To: T10 Technical Committee
From: Rob Elliott, HP (elliott@hp.com)
Date: 25 January 2005
Subject: 04-374r3 SES-2 Define a SAS Expander element

Figure 1 — Examples of diagnostic page contents

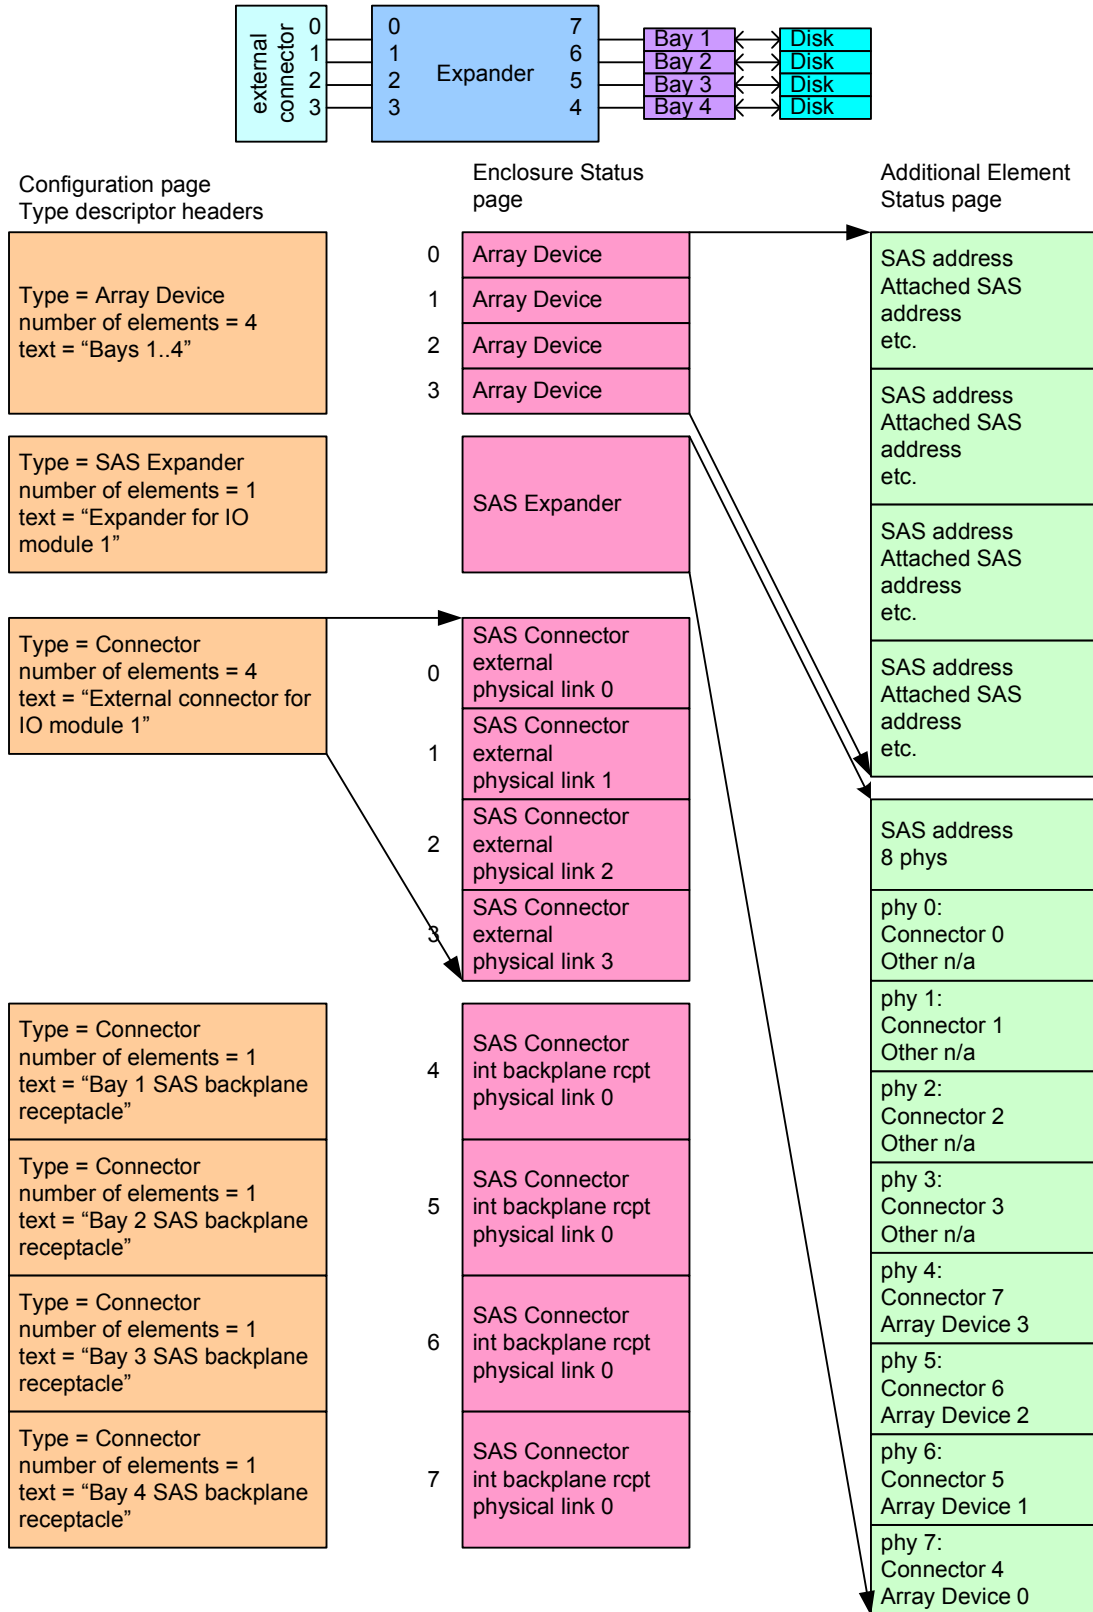
The following figure is an example of how the Configuration, Enclosure Status (elements), and Additional Element Status pages interact.
